Planner-led Pre-application No. PRR00042204 – Milldale Stages 4C, 10 – 13, WWTP Fast Track Pre-App		
Applicant	Fulton Hogan Land Development Limited	
Contact details	Contact	Nick Roberts / Rachel Morgan – Barkers & Euan Williams / Hannah O’Kane - Woods (Agents)
	Email	[REDACTED] [REDACTED]
Site address	Cemetery Road Wainui, Lot 2 DP 488814	
Proposal	Fast Track: To undertake earthworks and civil works to create sites for over 1,100 residential sites.	
Plans and information	Pre-app request dated 23/10 accompanied by application form, checklist and overview plans	
Meeting to be held		
Date, Time, Room	Tuesday 5 November 9-10am, online via Teams	
Proposed meeting participants – Customer / Agents	David Maclean Rachel Morgan Magdalena Regnault Euan Williams Emma Howie Jamie Whyte Tim Rickards Grant Fahey (apologies) Nick Roberts (apologies) Hannah O’Kane (apologies) Jo Sunde (apologies)	Fulton Hogan Land Development Limited Barker & Associates Barker & Associates Woods Woods Woods Woods Fulton Hogan Land Development Limited Barker & Associates Woods Woods

**Project:** Milldale Stages 4C, 10 -13, Wastewater Plant - Fast Track Consent Workshop

To:	Dylan Pope, Consultant Planner (AC) Carl

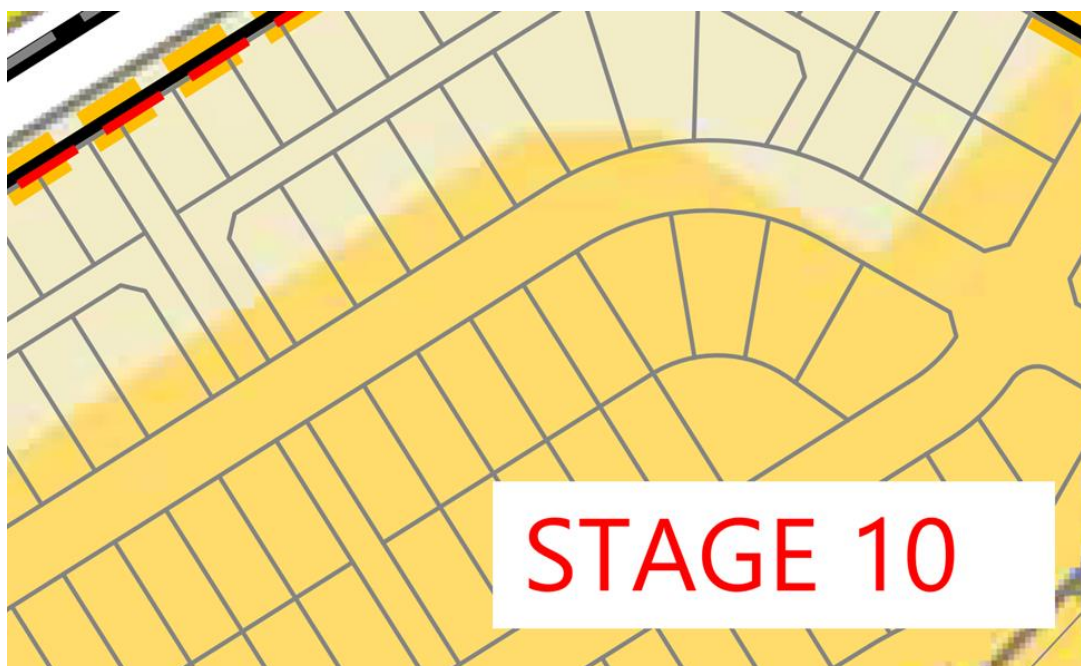
- The two local roads intersecting the collector road between stages 10 and 11 in the image below are too close together. This will result in a potential for conflict between drivers turning right into the side roads from opposite directions. The Applicant must consider revising their design for this intersection.

Figure 1: Council's Property Provision Team's mapping of overlaps between planned network, and existing catchments afforded by the stage 7 NP and the Suburban Park.

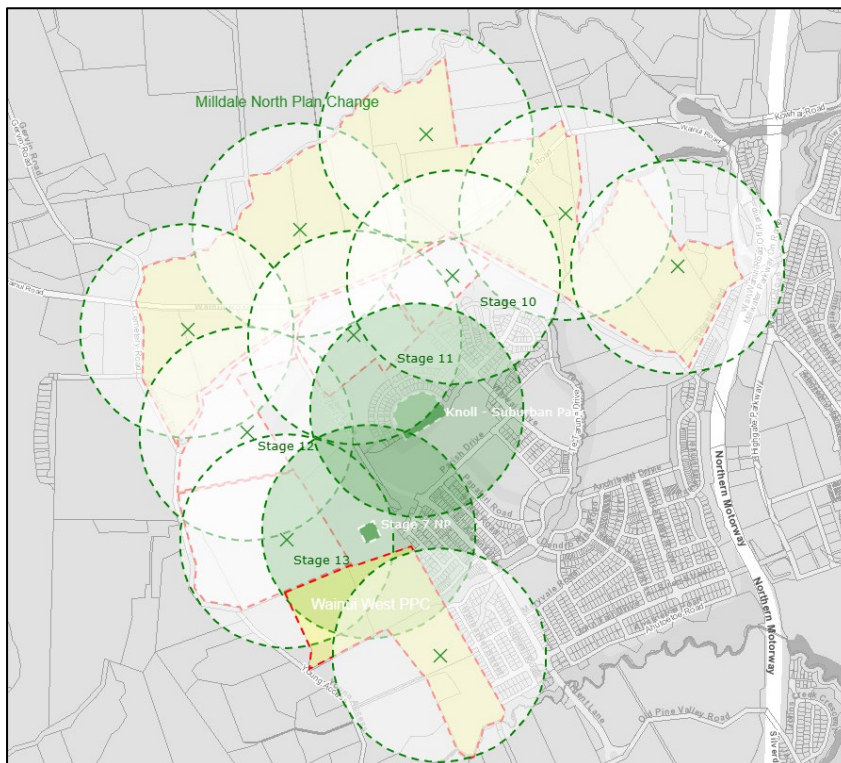
Political approval exists for four neighbourhood parks within the Stages 10-13 as per figure 1 above. Ongoing plan changes to the north and west of Mildale have impacted the broader acquisition of NP's within the Mildale catchment. According to Council's Principal Property Provision Specialist, Rahman Bashir, Figure 1 illustrates significant overlap between the planned networks and the existing catchments provided by the Stage 7 Neighbourhood Park and the central Suburban Park (Stage 9). Figures 1 and 2 include the application of a 450m ped shed as per policy requirements.

Figure 2: Redesigned network and overlaps with a 450m ped-shed.

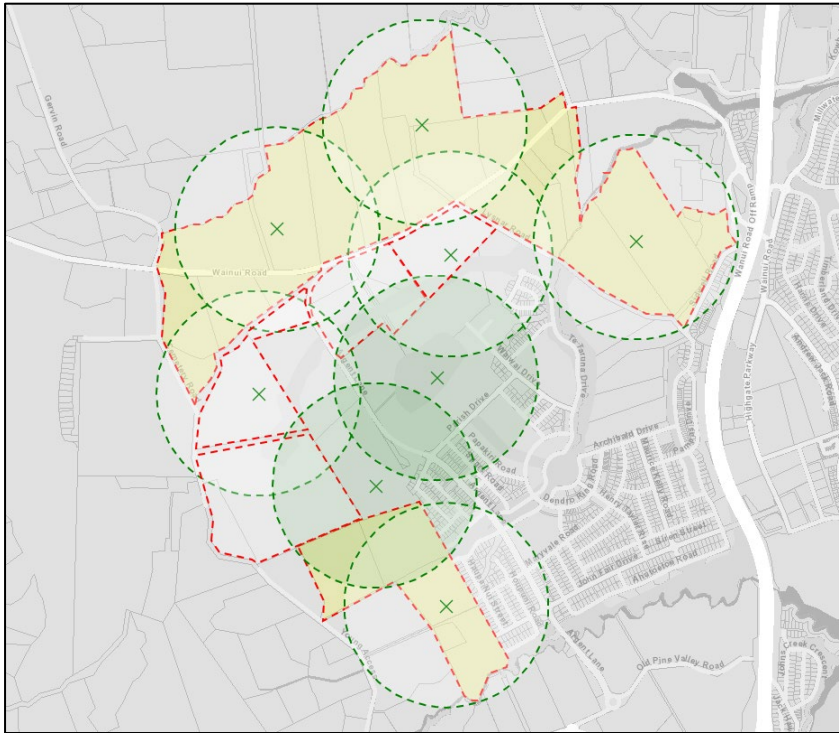
Noting the above, Council's Property Provision Team has outlined a preference for a redesigned network as per Figure 2 below, losing 2 parks within the fast track (Stages 11 & 13) area and utilising existing catchments. Council's Property Provision Team has based this assessment on applying a 450m pedshed as per policy requirements, with what they determine to be a validated low-density approach.

- Council's Property Provision Team recommends reducing the number of neighbourhood parks from four to two within Stages 10-13 (eliminating parks in Stages 11 and 13). This adjustment would leverage the existing catchments whilst the proposed redesign is based on policy requirements for a 450m ped-shed, validated through the low-density nature of the area. The aim is to optimise park distribution and avoid unnecessary overlaps within the network and lodged northern and western plan changes.

Figure 3: Possible activation areas and public amenity.  
*Road Typology Plan, November 2024 with Cas Hannink Edits.*

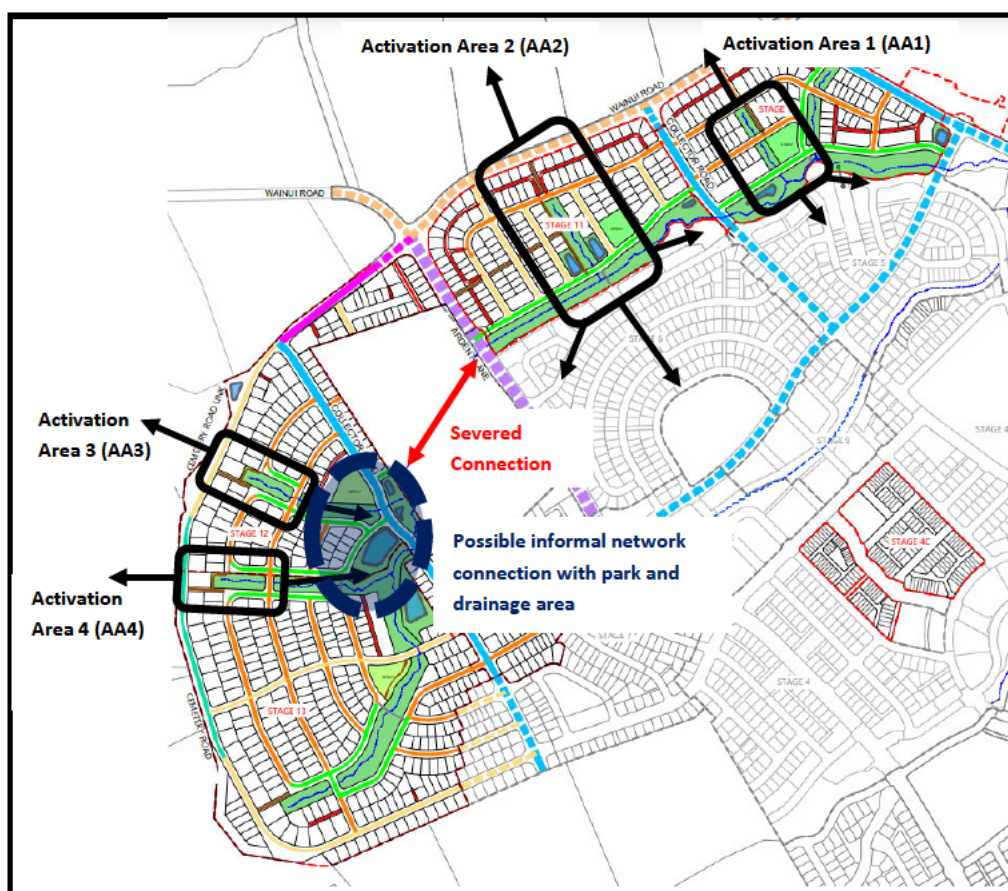
The workshop indicated that the applicant proposes to vest the below green network as drainage reserve. Parks Planning does not determine if drainage reserves are accepted for vesting, this determination lies with Healthy Waters. Healthy Waters have engaged Parks Planning to provide high level pedestrian and public amenity activation comments, aiding in any determination for vesting. The applicant is please requested to clarify the intended function of the proposed draiange reserves and how these reserves will contribute to public amenity and activation.

Referring to Figure 1, the proposed reserve lots show limited activation due to a break in continuity caused by Lot 4 DP 151229 (147 Argent Lane, Upper Orewa). According to the precinct requirements under I544.10.1 Wainui: Precinct Plan, the reserve edge road is designed to enhance activation, as illustrated in the cross-section featuring a 3-meter recreational path within the road reserve (DWG No - P24-128-00-2015-RD). Preliminary plans indicate that accessways prioritise activation along the reserve edge road and through AT-vested accessways, rather than relying on pathways within the reserve areas.

Based on the high-level plans and Figure 3 above, the following Activation Areas (AA's) have been identified:

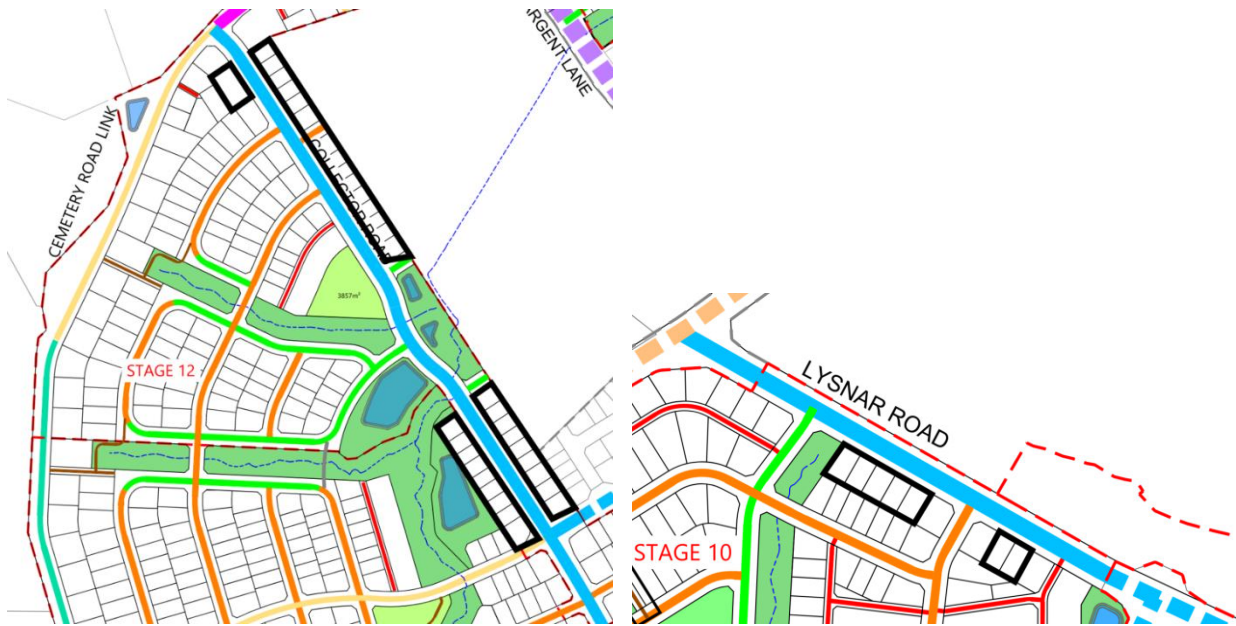
**Stage 11:** At the two locations shown in black in the figure above, there is a pedestrian link that runs between or adjacent to the JOALs. We recommend the designs in the next phase ensure clear and deliberate separation, to prevent vehicles on these JOALs from accidentally driving onto the pedestrian path. We also would recommend good separation between the access to these pedestrian links and any adjacent vehicle crossings.

**Stage 12:** The above figure indicates parallel accesses from the Cemetery Road Link. It is unclear if any turnaround space has been provided. We would like to confirm if there is an east-west link between the yellow link (local road type 2) and the eastern-most red link (JOAL).
